REVISED DETAIL OF BASEPLATES & JOINTS FOR 4'-6" DIA. & 5'-0" DIA. CLARKSON BOILERS.

Amended plan of
base plates.

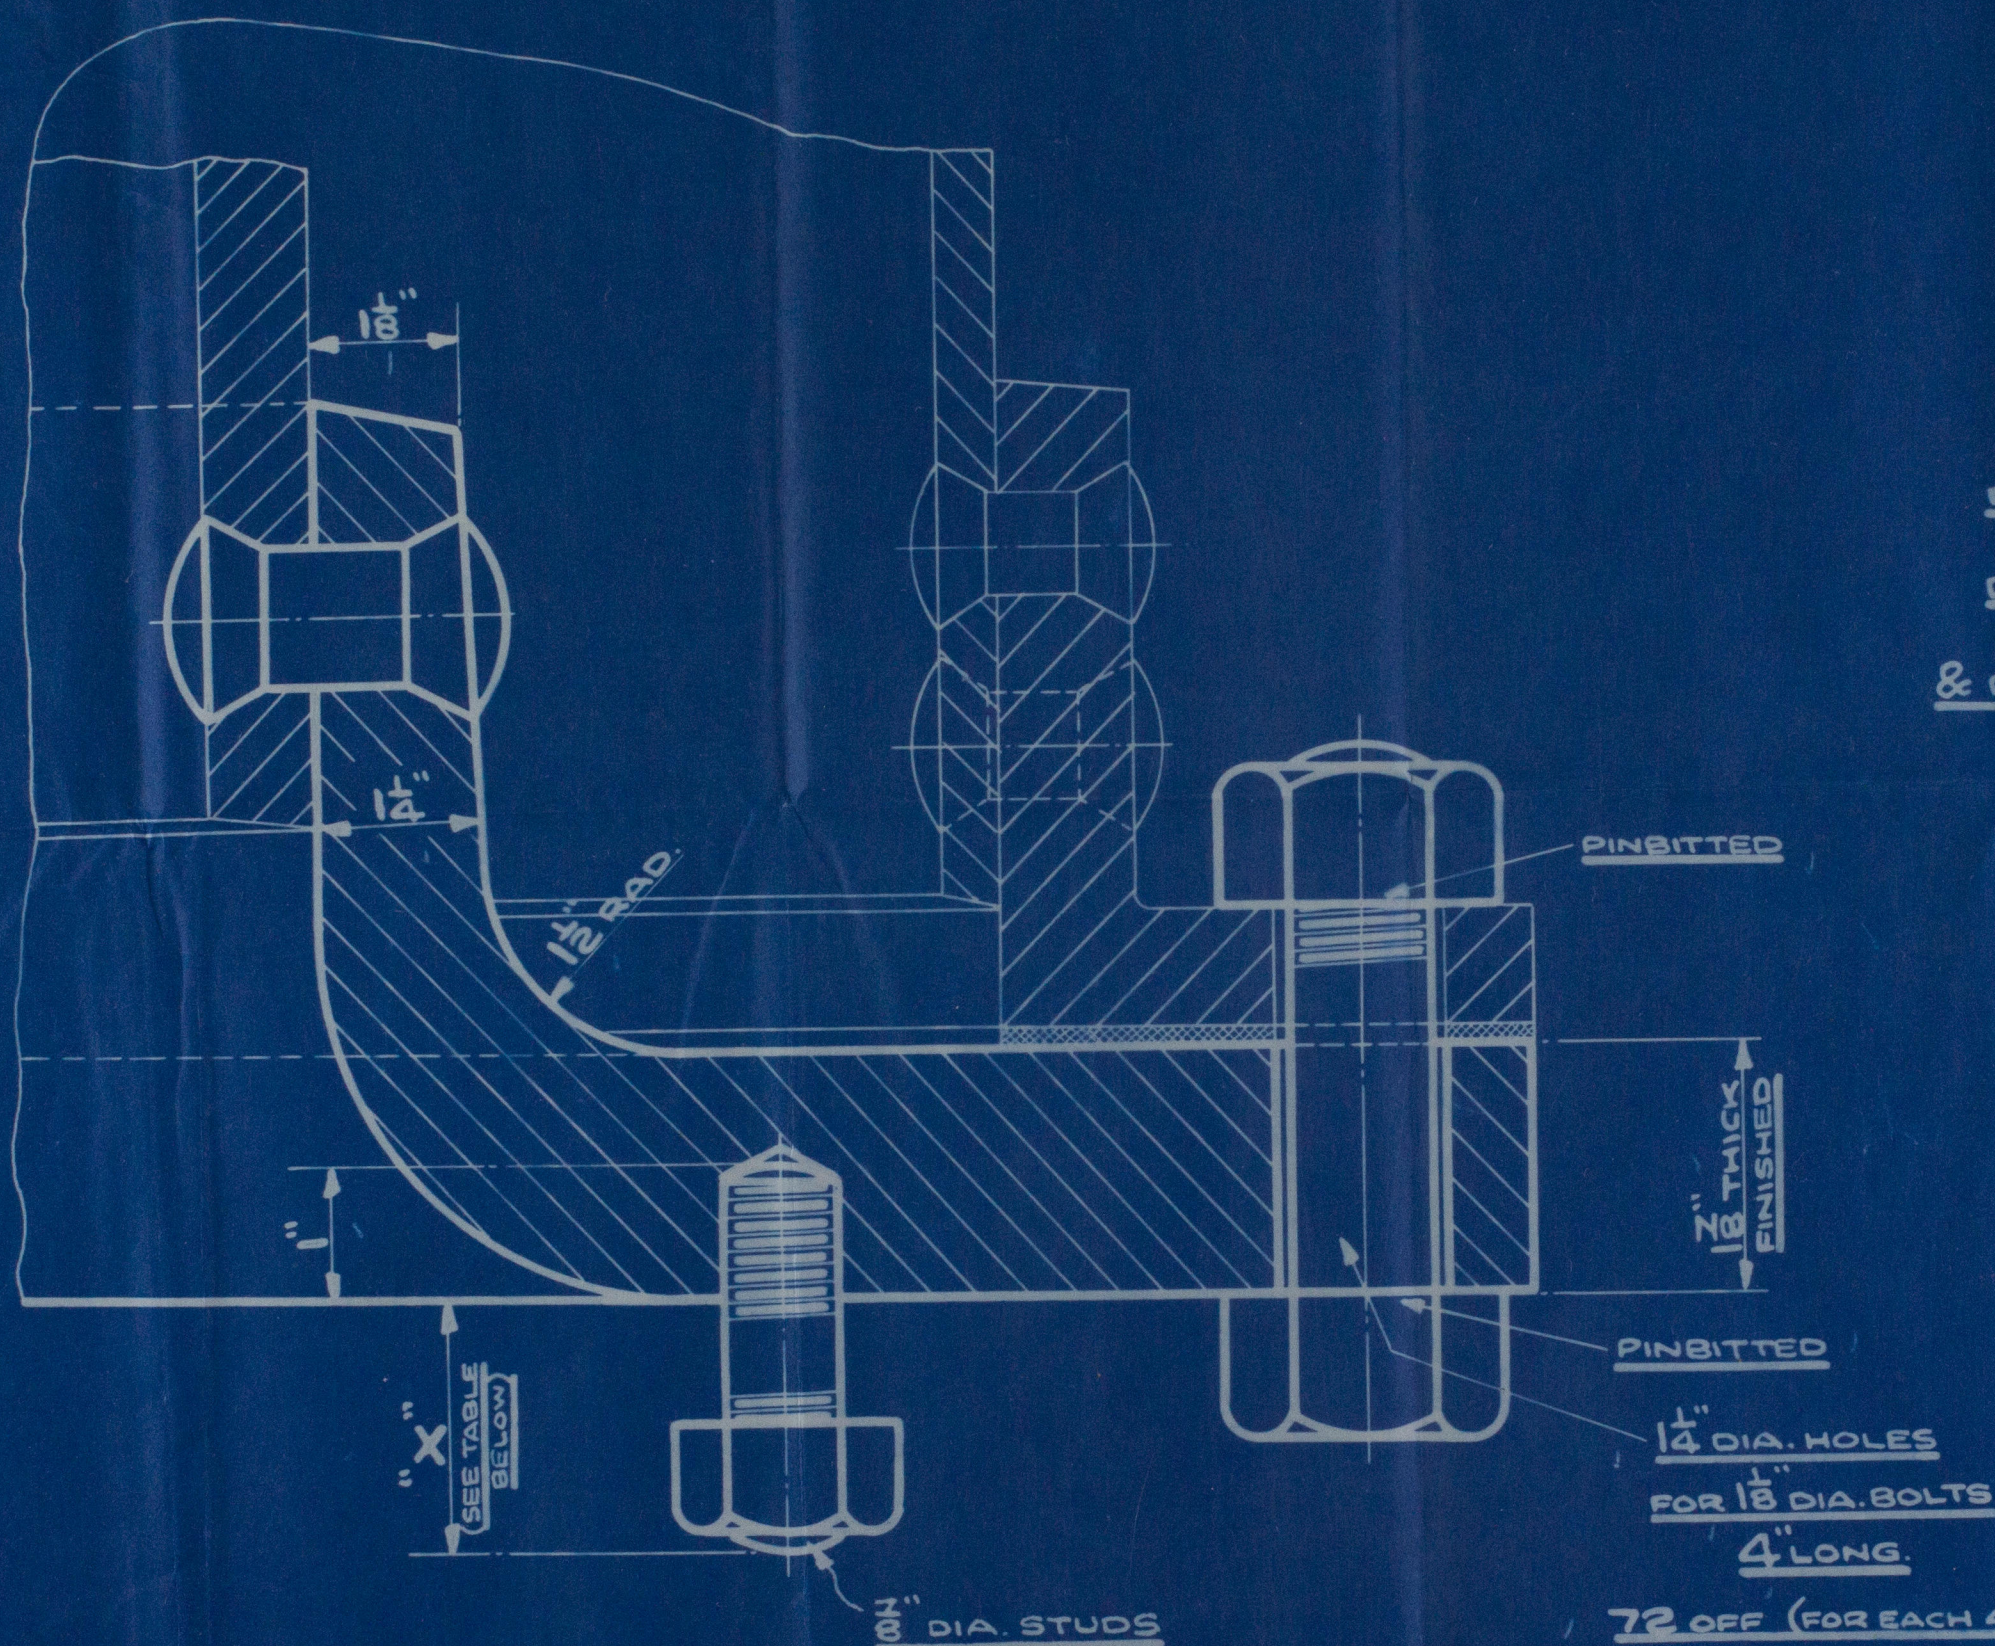
FOR ORIGINAL DETAILS OF JOINTS SEE
DRAWING NO 10214.A. (5'-0" DIA. BOILERS)
& DRAWING NO 10221 (4'-6" DIA. BOILERS)
